Sent: 25/08/2020 7:30:40 PM
Subject: DA2020/0824 (321-331 Condamine Street, Manly Vale)

We have the following concerns around the DA2020/0824 (321-331 Condamine Street, Manly Vale). This is a joint submission from residents of Sunshine Street.

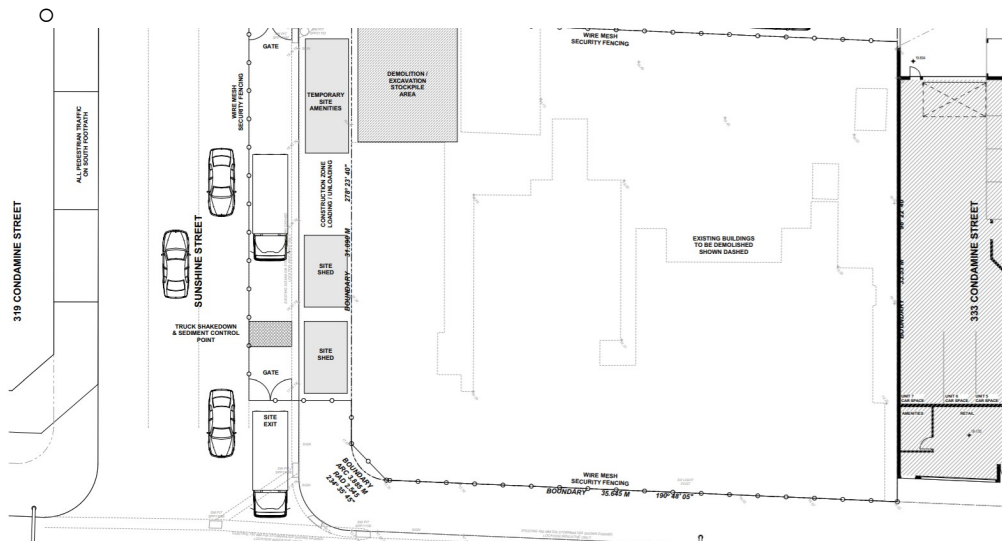
- Congestion along Somerville Place is currently an issue and this laneway was not built to cope with
- The current intersection of Sunshine & Somerville presents an unacceptable risk to pedestrians, p
 - Cars not stopping at the stop sign at Sunshine street
 - Cars speeding down Somerville Place, a narrow laneway
 - Walking east along Sunshine Street it is not clear to pedestrians that this is a road intersecting

- It's not clear to vehicles moving along Somerville whether it's a footpath or road.
- Cars on Sunshine Street can not see children approaching from the west due to the height of the front fence

- Given Sunshine Street is a major thoroughfare to Manly Vale Public School and therefore many children
 - Additional traffic volume
 - Reduced line of sight for vehicles on the east side of the intersection (while driving along Sunshine Street)
- In the DA the traffic study characterises vehicles turning right onto Sunshine Street from Somerville Place
